RE: Testimony to City Council Regarding Appeal of Riverscape Apartments
Decision by the Design Commission, April 18, 2013, LU 12-212602 DZM GW
AD

RIVERSCAPE APARTMENTS

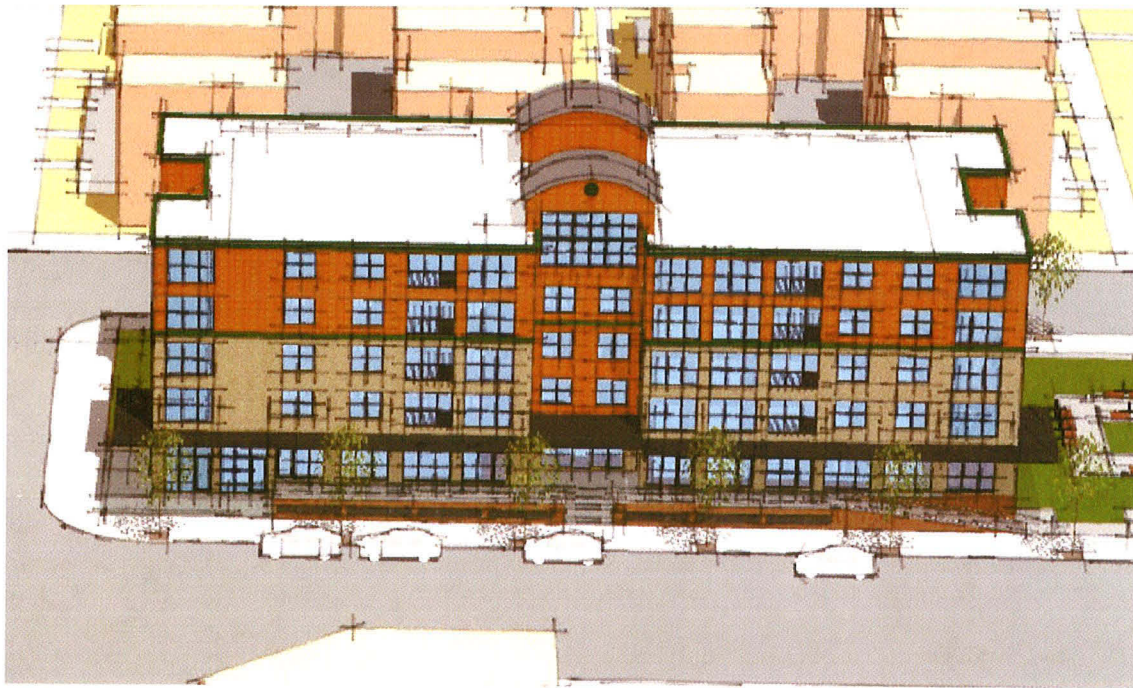
Second, the sidewalk context is awkward, with semi-private residential patios and awkward ramps and grade transitions. Overall, our committee would prefer a more simplified approach, without the loading dock feature, and with floor levels at the sidewalk level in the commercial lease areas and the live/work spaces.

937 GLISAN

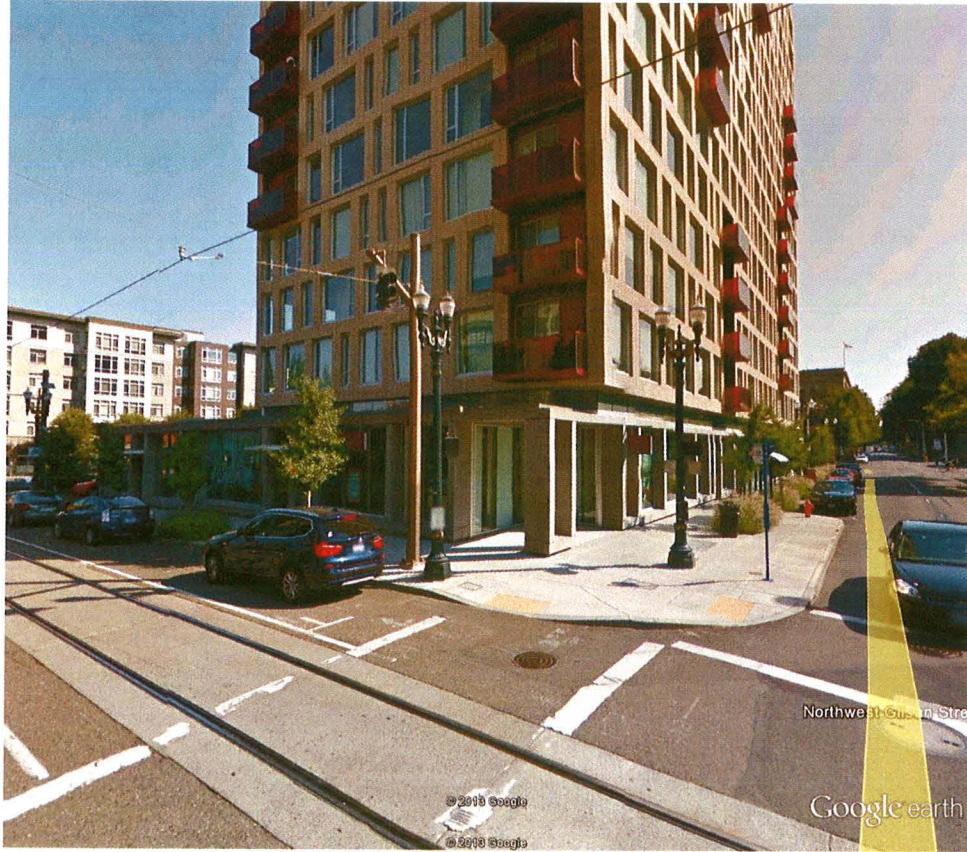
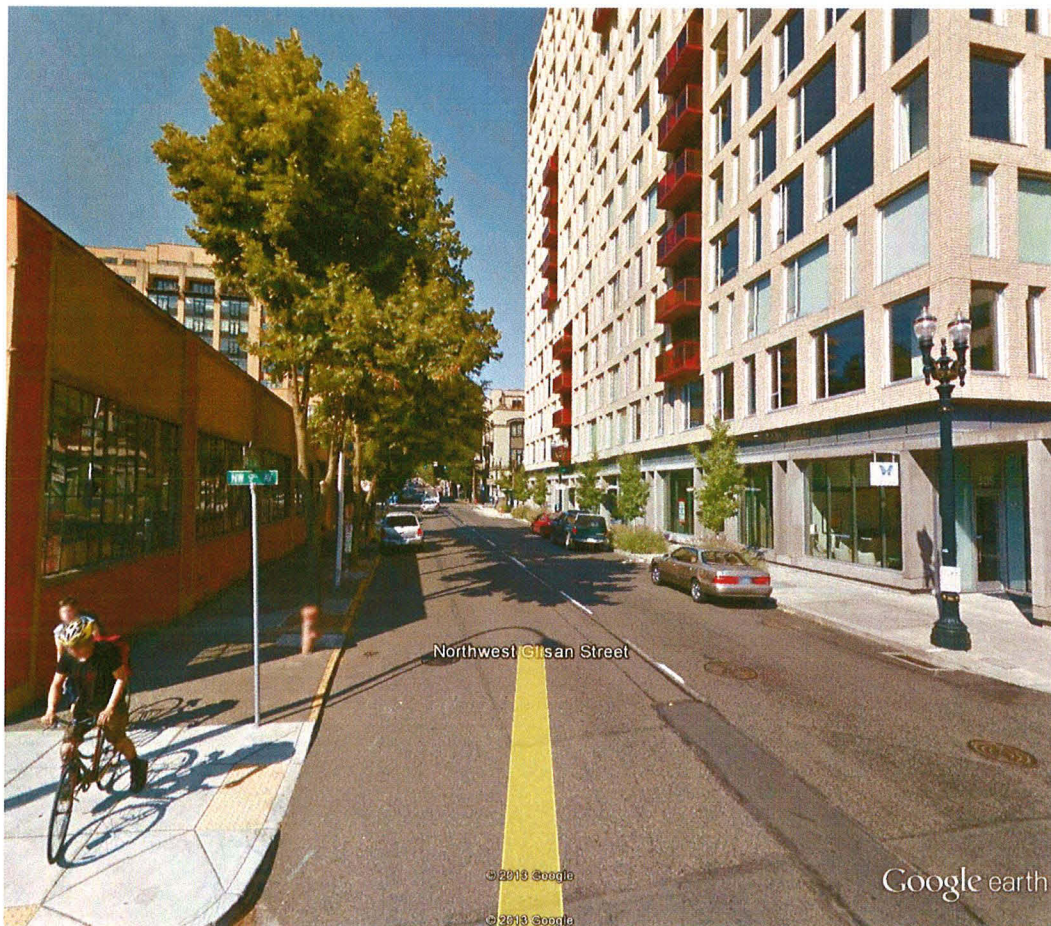
The 937 Glisan building is located at NW 9th and Glisan, with the long façade facing Glisan. The building is about 75 feet in depth. It includes real balconies for each unit on every façade, narrow and long. These elements would work on a shorter building, such as at Riverscape.
